ENVIRONMENTAL PROTECTION AGENCY

National Emission Standards for Hazardous Air Pollutants for Source Categories: Organic Hazardous Air Pollutants From the Synthetic Organic Chemical Manufacturing Industry and Other Processes Subject to the Negotiated Regulation for Equipment Leaks

ACTION: Final rule; amendments.

Figure 1. ALTERNATIVE EXPERIMENTAL METHODS FOR DETERMINING THE FRACTION OF ORGANIC COMPOUND BIODEGRADED (Fbio) IN A BIOLOGICAL TREATMENT UNIT

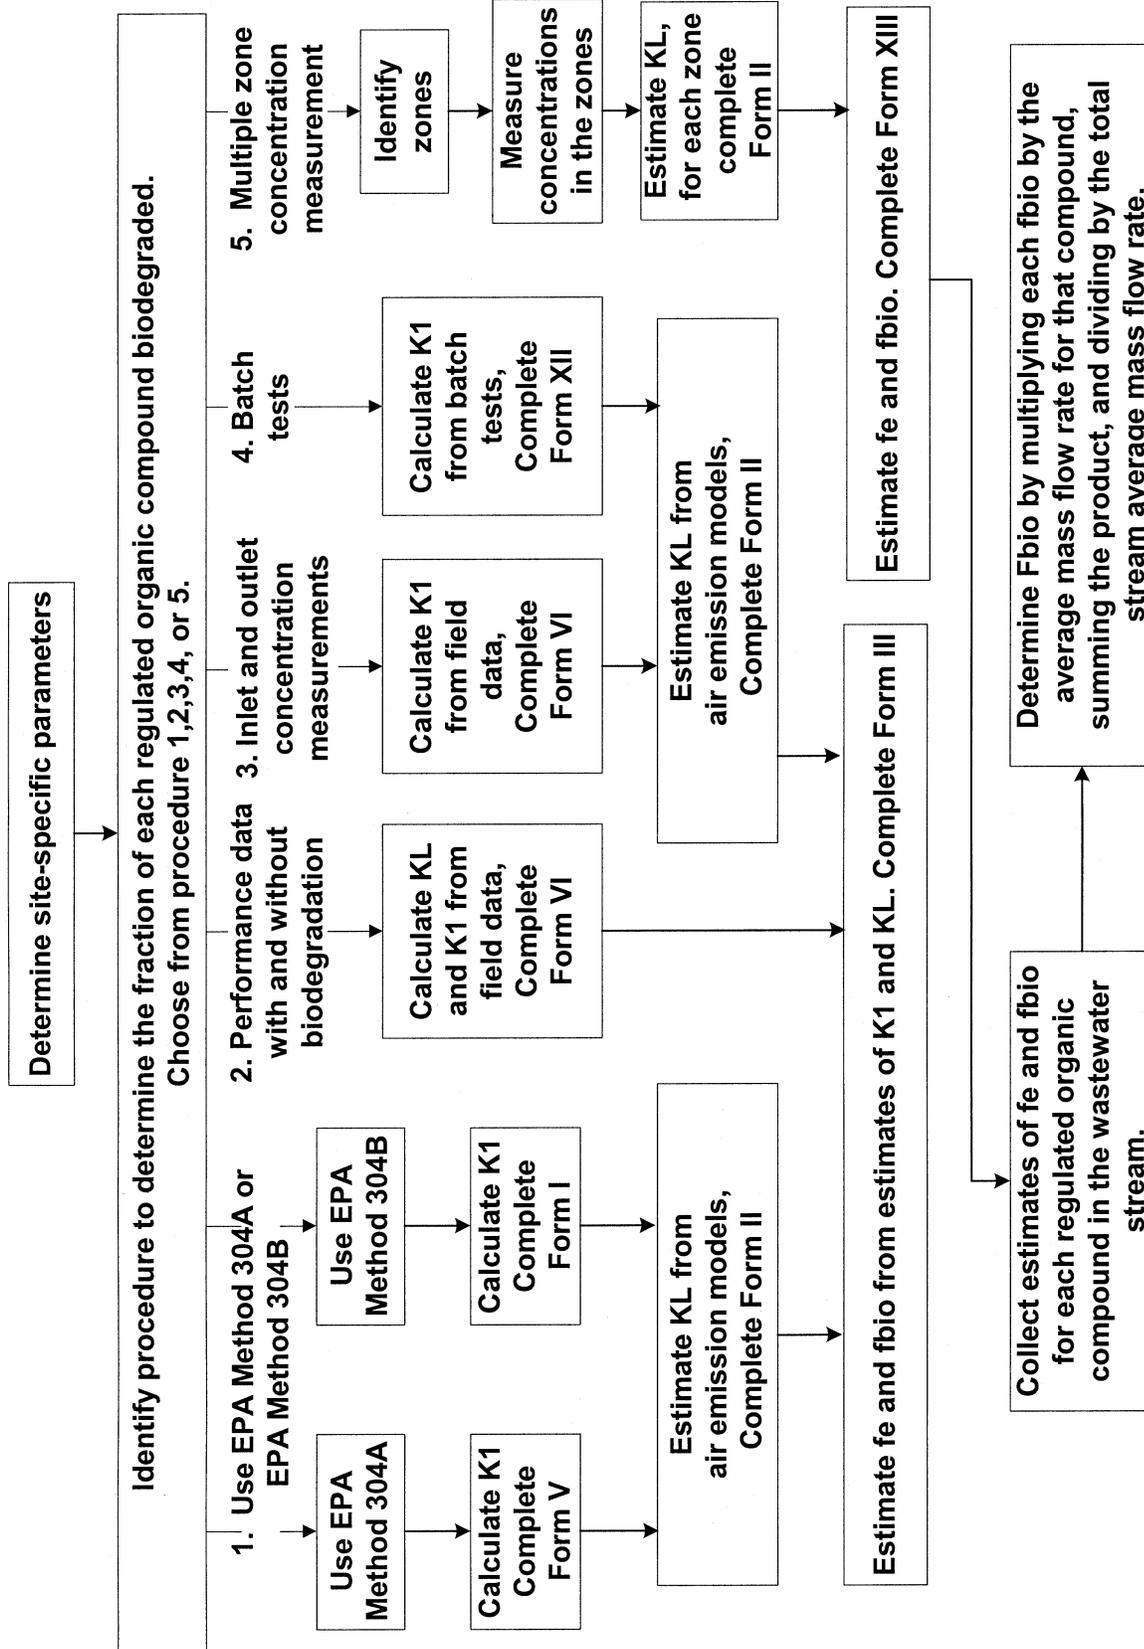
g. Revising Figure 1; and

performance data on a biotreatment unit prior to and after addition of the microbial mass. An example where Procedure 2 could be used is an activated sludge unit where measurements have been taken on inlet and exit concentration of organic compounds in the wastewater prior to seeding with the microbial mass and startup of the unit. The flow chart in figure 1 outlines the steps to use for each of the procedures.
